SERVICE BULLETIN

Service Bulletin No. / Date: SB TMG 651-1008 P1, Initial Issue / May 25, 2018

Subject: Rework of the engine mount

Type affected: Piper PA-28-181 ARCHER III with TAE 125-02-114 installation

Figure 1: Affected plate

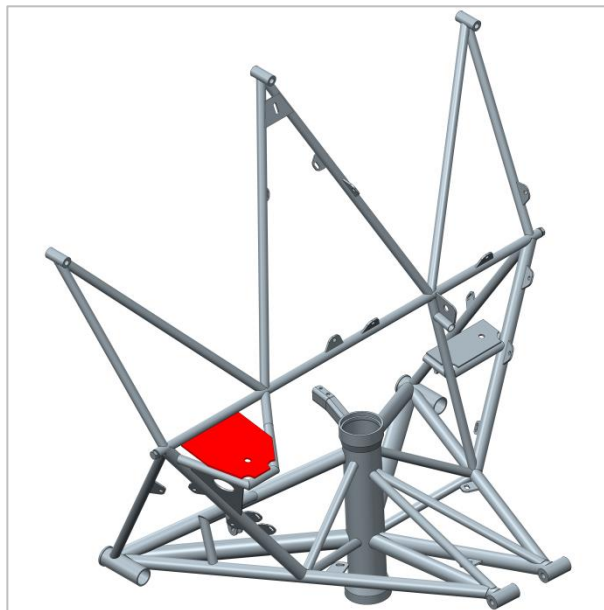
Reason: Incorrect position of the borehole on the right engine mount plate.
